LPA Ref: 22/00752/OUT

Forest Hill Golf Club, Botcheston

Appeal Statement (Highways)

(August 2023 Revision B)

PLAN A – IMPLICATIONS OF POTENTIAL IMPROVEMENTS TO EXISTING
GOLF COURSE ACCESS (OVERLAID ONTO GOOGLE EARTH MAPPING)
[INDICATIVE ONLY – DO NOT SCALE]

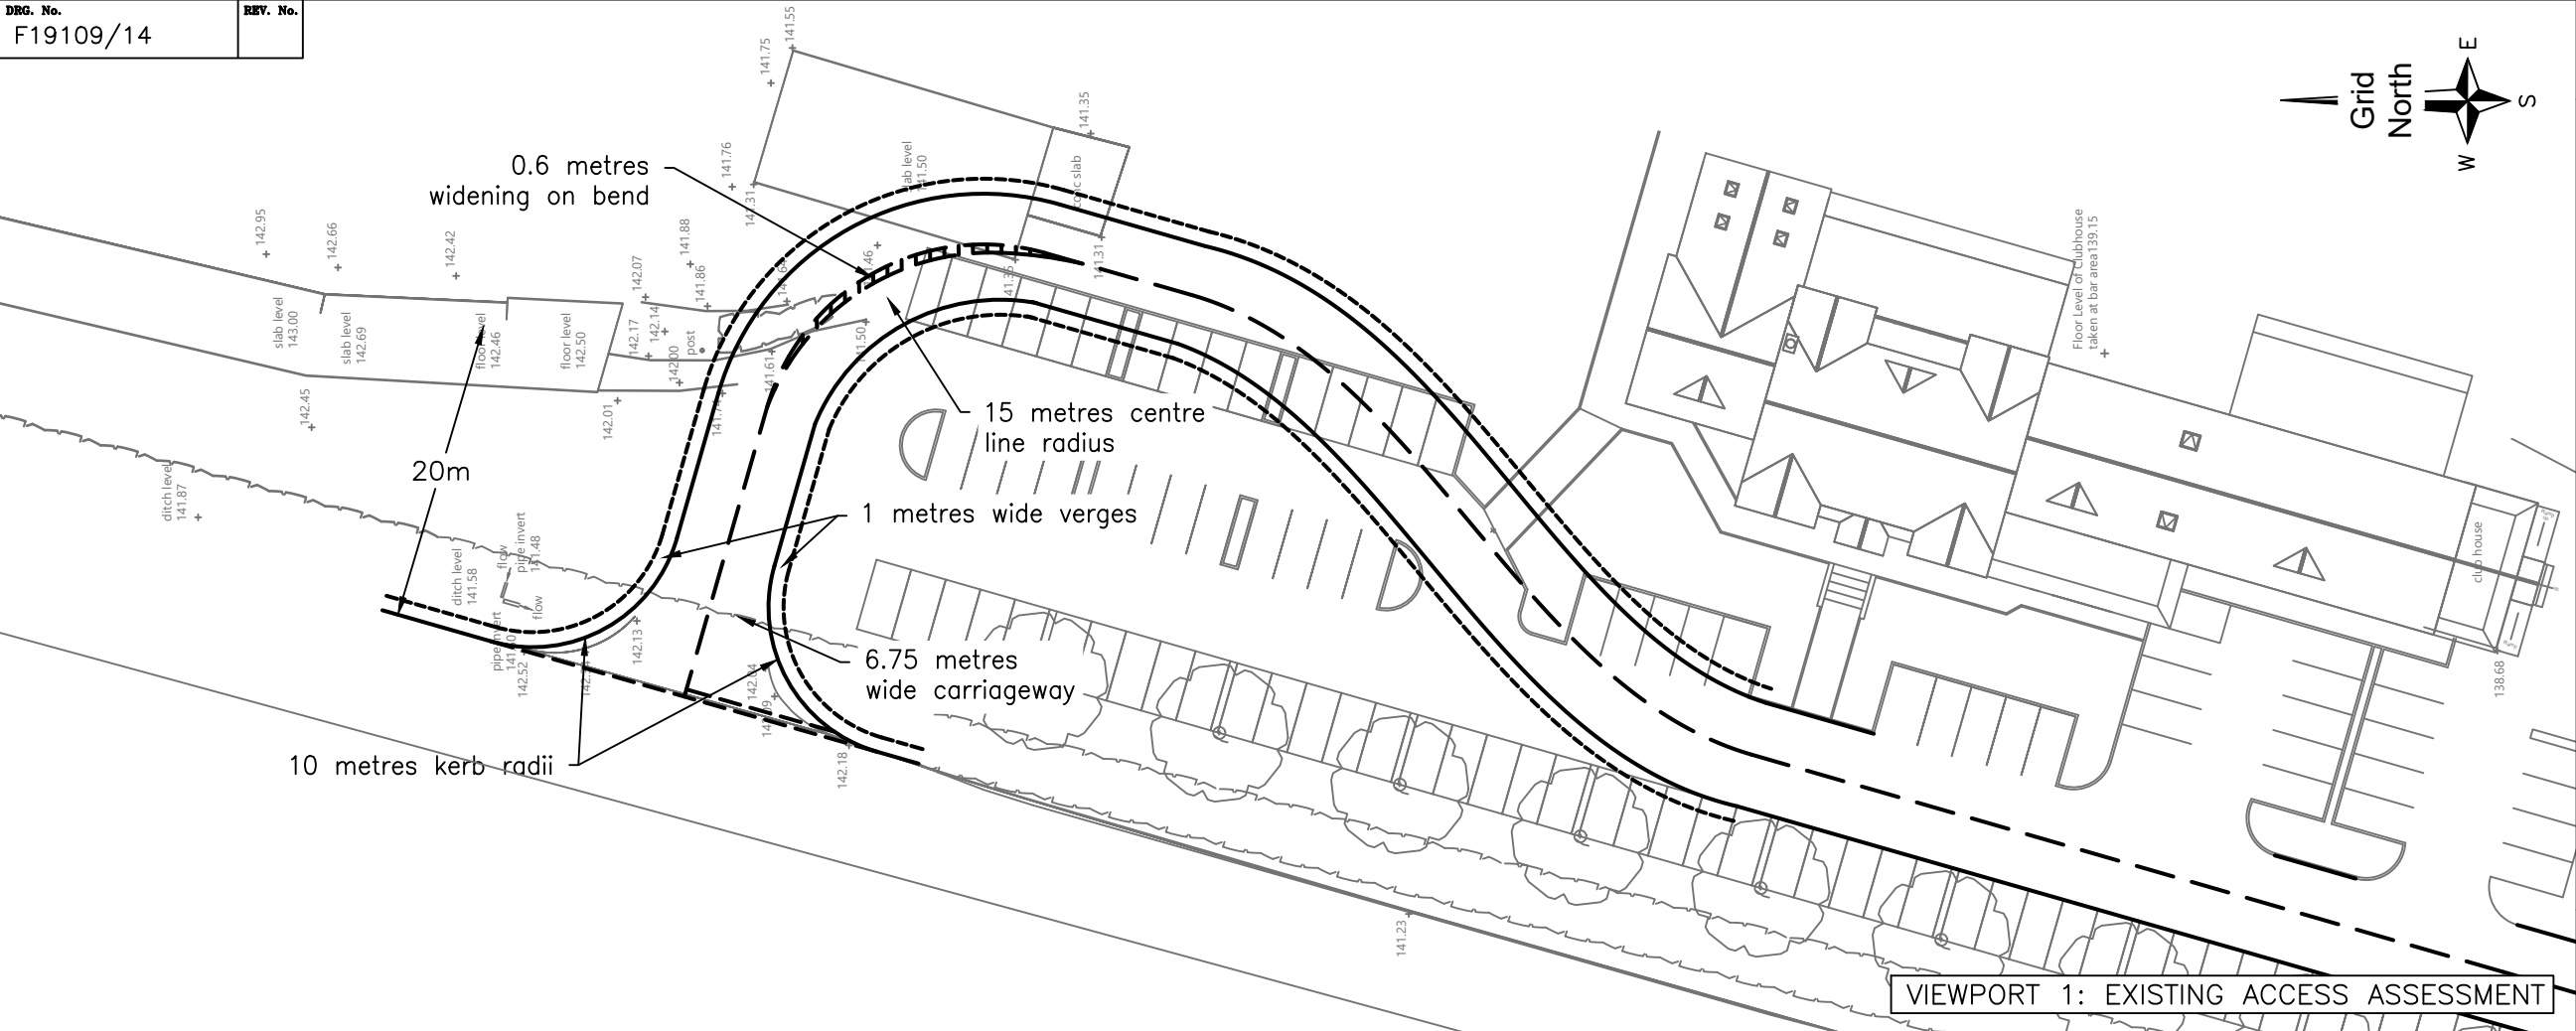
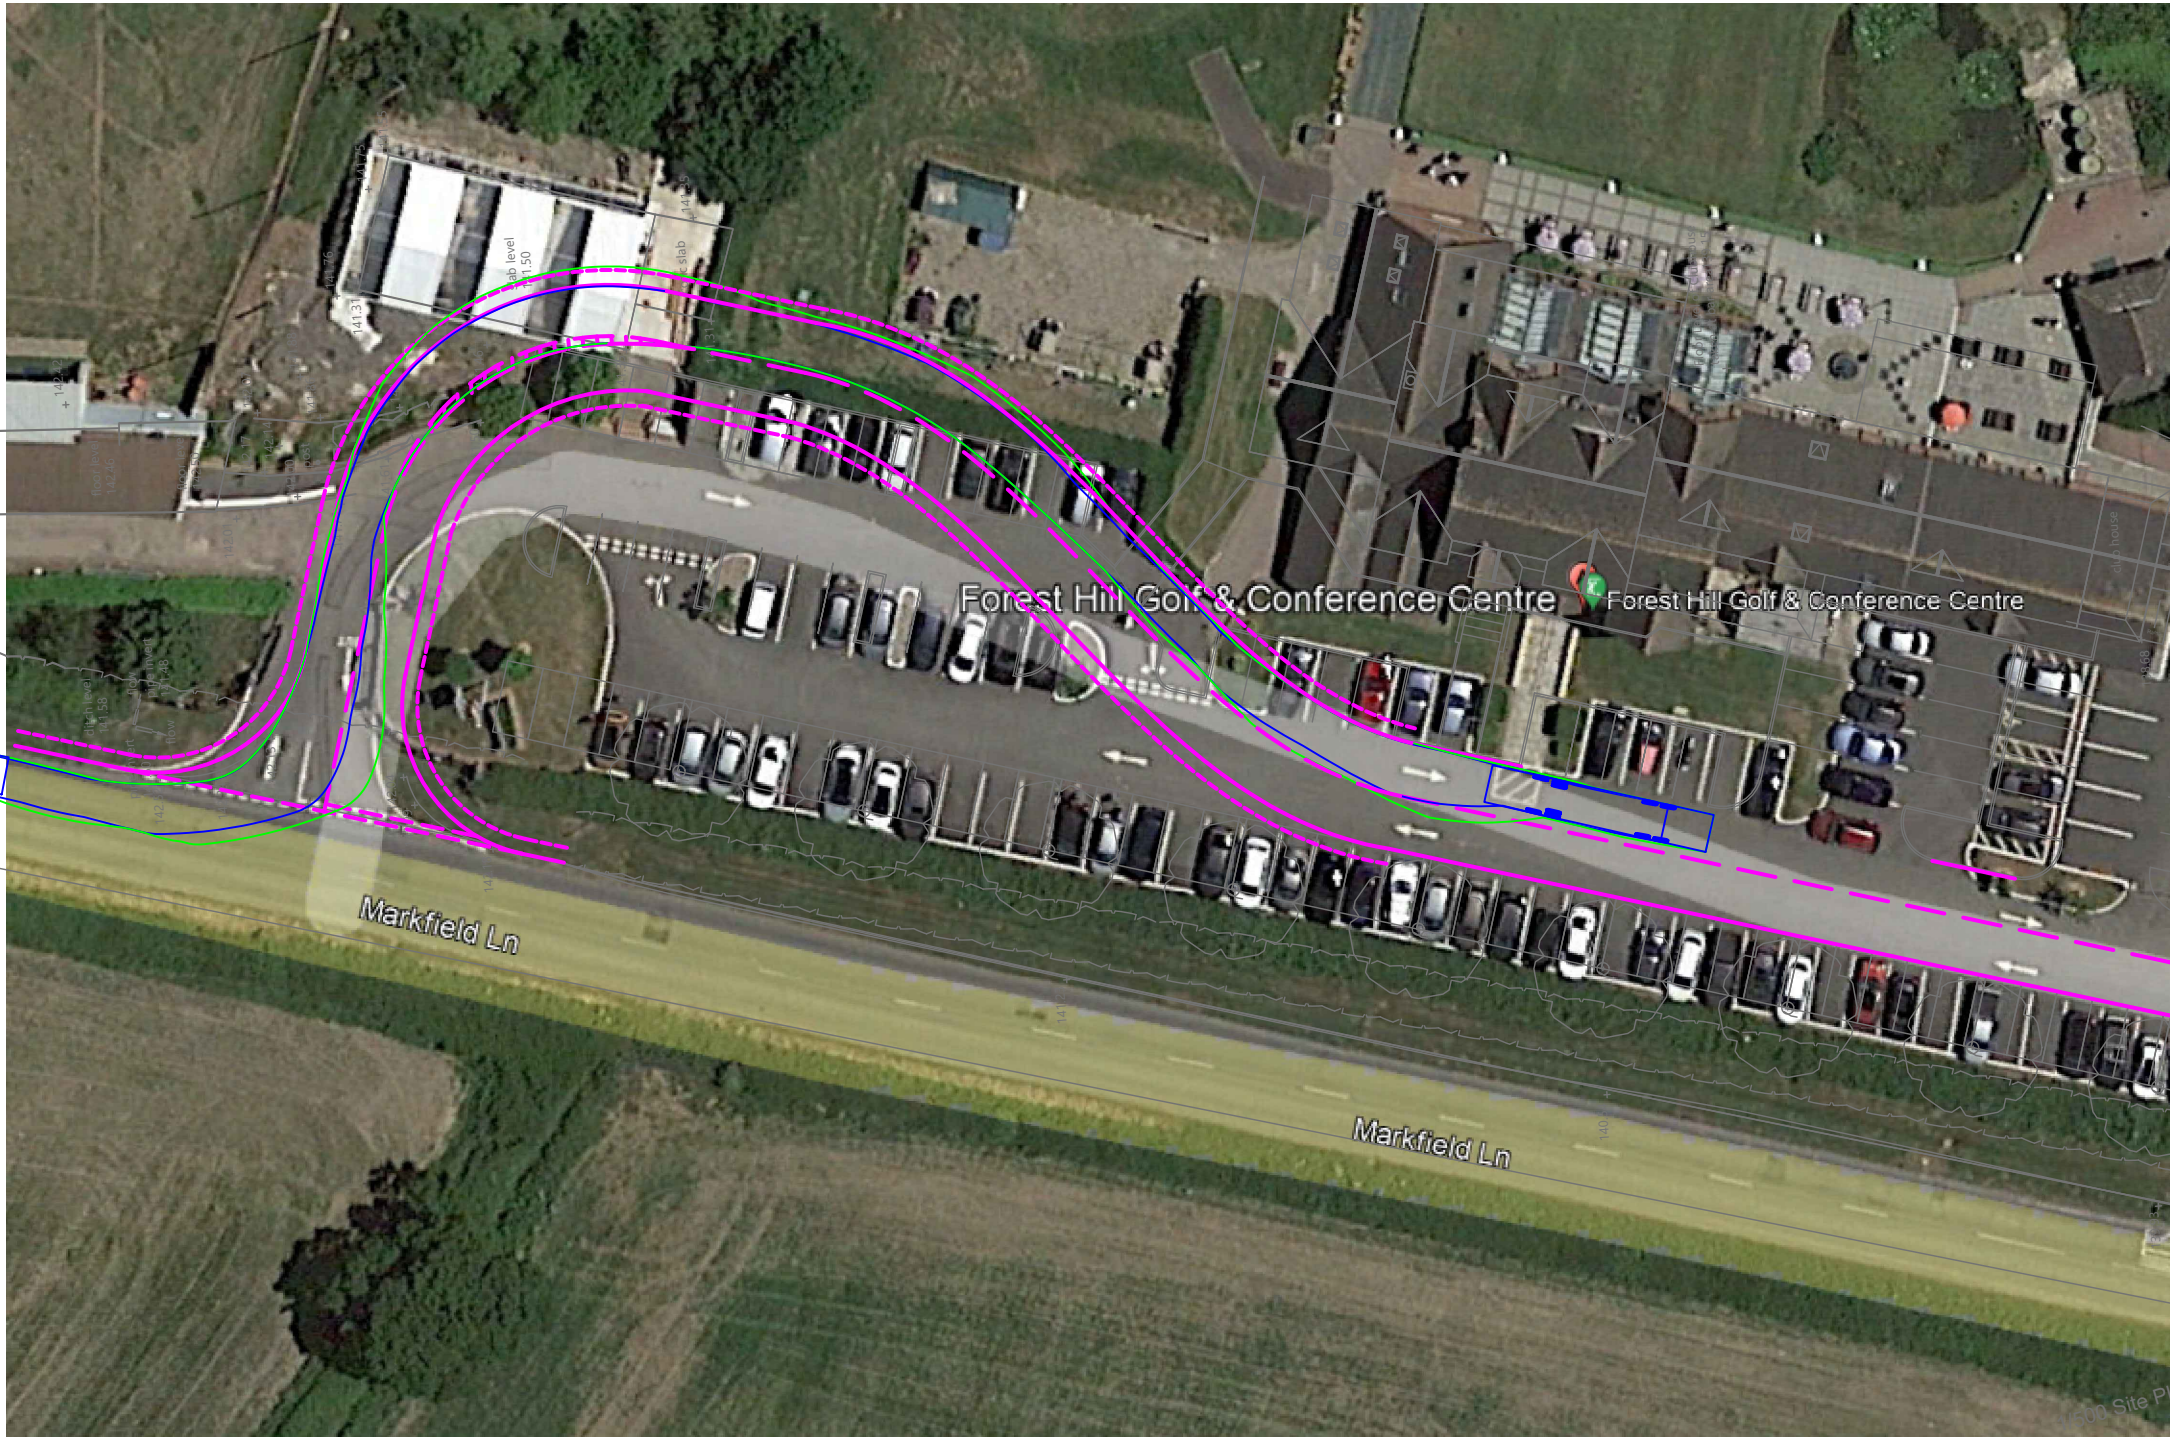
In response to these outstanding points, I have previously explained how the Highway Authority's own design guidance (Figure DG2a and Table GD5 Broad Junction Types) uses an example of skewed junctions located at the inside of a bend within its examples of good practice for plotting visibility splays. I would also mention how the Highway Authority has confirmed it would accept the existing access layout/location to serve the proposed development, without the need for any right turn lane facilities. I find this position confusing and would again stress how current planning policy requires that there must be clear evidence of a specific problem for an application to be refused.

enc Drawing Number F19109/14
PLAN A – Implications of Potential Improvements to Existing Golf Course Access
Figure CB1 - 2027 Design Year Flows (Prop Dev @100% + MCC Golf Club)
Figure CB2 – 2027 Design Year Flows (Prop Dev x 2 + MCC Golf Club flows)
Table CB1 – PICADY Assessment Summary – Prop Site Access (Sens Test)
PICADY Output details

CB1

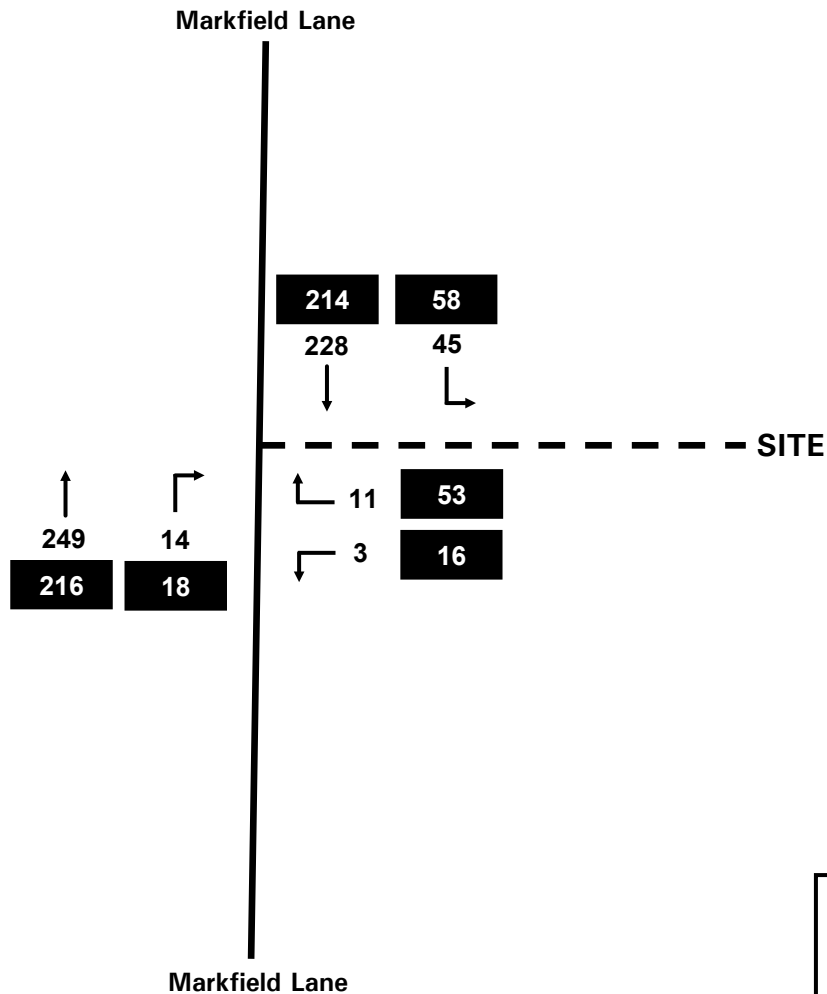
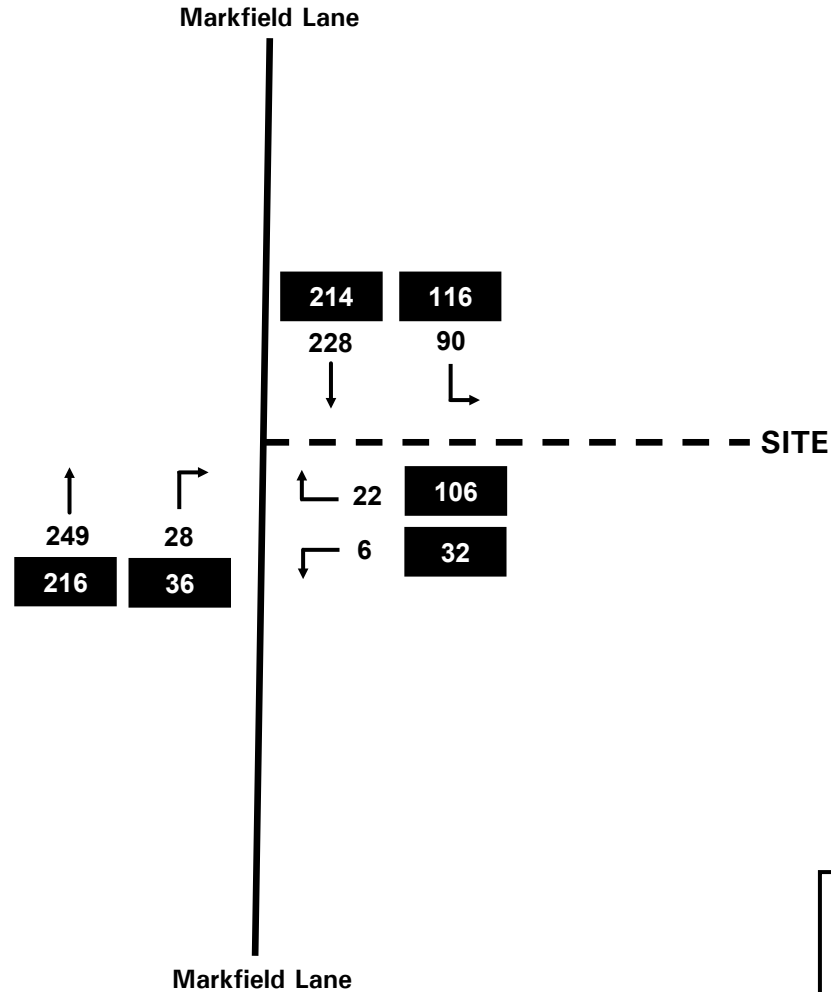
These flows are summarised within the enclosed Figure CB1, assigned to the network in accordance with the established turning proportions from the survey. Whilst I maintain the view that a significant proportion of hotel trips would be associated with the existing golf course, the removal of any trip reduction factors will, we hope, help to allay the Highway Authority's concerns. Nevertheless, in lieu of any outstanding concerns the officer might have regarding trip generation, I have also undertaken a further sensitivity test whereby all development turning movements associated with the site access have been doubled, so existing golf club and proposed hotel trips (unadjusted) are modelled at 200% of the likely worst-case scenario.

Numbers have been rounded.
Note – development traffic (shown
in Figure CB1) has been doubled.
